Access Compliance Report

Public Rights-of-Way

Intersection ID: 14831	Main Street: BARFIELD_DR	Cross Street: MANCHESTER_DR	Location: NW
ADA ID: FC29D2D3F24D	Ramp Type: BlendTrans1	Initial Pass/Fail: Fail	Overall Compliance: No
		Severity Score: 42.5

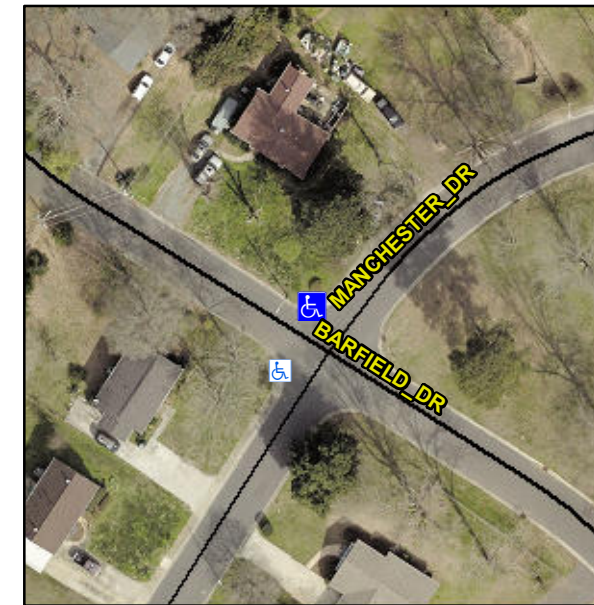
Not Found, R304.5.1, R304.5.3

Compliance	Description	Data	Compliance	Description	Data
N/A	Ramp Length (in)	48.0	Yes	BlendTrans Slope (%)	4.2
No	Ramp Width (in)	35.0	No	BlendTrans XSlope (%)	7.8
N/A	Flare Type LT	N/A	N/A	Flare Type RT	N/A
N/A	Flare Slope LT (%)	N/A	N/A	Flare Slope RT (%)	N/A
N/A	Flare Traversable LT?	N/A	N/A	Flare Traversable RT?	N/A
N/A	Landing Length (in)	N/A	N/A	DWS Provided?	N/A
N/A	Landing Width (in)	N/A	N/A	DWS Contrast?	N/A
N/A	Landing Slope (%)	N/A	N/A	DWS Length (in)	N/A
N/A	Landing X Slope (%)	N/A	N/A	DWS Full Width?	N/A
N/A	Landing Curb? (Y/N)	N/A	N/A	DWS Offset (in)	N/A
N/A	Shared Landing?	N/A			
N/A	Gutter Ponding?	N/A	N/A	Gutter Slope (%)	N/A
N/A	Gutter Lip Ht (in)	N/A	N/A	Gutter X Slope (%)	N/A
N/A	Painted X Walk1?	No	N/A	Painted X Walk2?	No
	X Walk 1 Direction	To SW		X Walk 2 Direction	To SE
	X Walk 1 Width (in)	N/A		X Walk 2 Width (in)	N/A
	X Walk 1 Slope (%)	10.9		X Walk 2 Slope (%)	3.4
	X Walk 1 X Slope (%)	1.4		X Walk 2 X Slope (%)	7.5

N/A	Ramp inside XWalk1?	N/A	N/A	Ramp inside XWalk2?	N/A
	Road Slope (%)	4.5		Clear Space?	N/A
	Road X Slope (%)	8.2	N/A	Clear Space to XWalk (in)	N/A
N/A	Any Obstructions?	N/A	N/A	Storm Grate/Utility Hazard?	N/A
	Obstruction Type			Storm Grate/Utility Type	
		N/A			N/A
			Yes	Surface Condition? (G/P)	Good
			No	Curb Slope (%)	10.6

Remove & Replace Curb Ramp With Two New Directional Ramps or Equivalent.
